Staff Report
City of Richmond, Virginia

Commission of Architectural Review

1. COA-164401-2025	Final Review Meeting Date: 4/22/2025
Applicant/Petitioner	Brian Johnston
Project Description	Construct a new 8x14 tool shed
Project Location	
Address: 2614 E Franklin St, Richmond, VA 23223	
Historic District: St. John's Church	
<p>High-Level Details:</p> <p>The applicant proposes the construction of a new 8 x 14 tool shed. This project is presented for review after partial construction had already begun. Following a notice of violation, staff met with the applicant and provided guidance on the review process.</p>	
Staff Recommendation	Approval, with Conditions
Staff Contact	Yara Iwaz, Yara.Iwaz@RVA.gov, (804)646-6031
Previous Reviews	<ul style="list-style-type: none"> N/A
Staff Recommendations	<p>Staff finds that the proposed shed is appropriate for rear yard placement. Staff recommends approval with the following condition:</p> <ul style="list-style-type: none"> Confirm final roofing selection and ensure that, if metal roofing is used, it is of a historically compatible profile (standing seam panels, not corrugated or ribbed panel type) Confirm and abide by any other zoning regulations

Figure 5: Neighboring shed structure

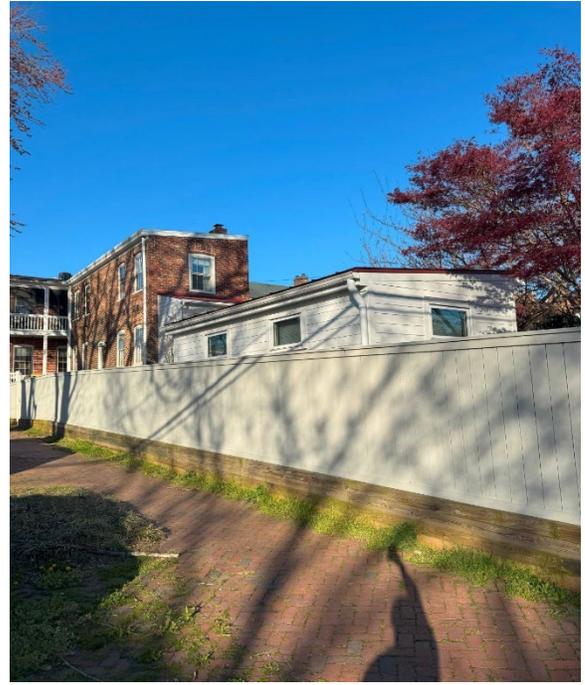
Guideline Reference	Reference Text	Analysis
New Construction, Residential Outbuildings, page 51	<i>1. Outbuildings, including garages, sheds, gazebos and other auxiliary structures, should be compatible with the design of the primary building on the site, including roof slope and materials selection.</i>	<p>The tool shed is appropriately sited in the rear yard, is appropriate in scale, and uses simple wood siding with painted trim.</p> <p><u>Staff recommends that the siting of the shed should also abide by any other zoning regulations.</u></p>
New Construction, Residential Outbuildings, page 51	<i>2. Newly constructed outbuildings such as detached garages or tool sheds should respect the siting, massing, roof profiles, materials and colors of existing outbuildings in the neighborhood.</i>	<p>The proposed wood siding with vinyl trim is consistent with accessory buildings in the district.</p> <p>The applicant provided photos of similar structures in the neighborhood which appear to be of similar material and design.</p>
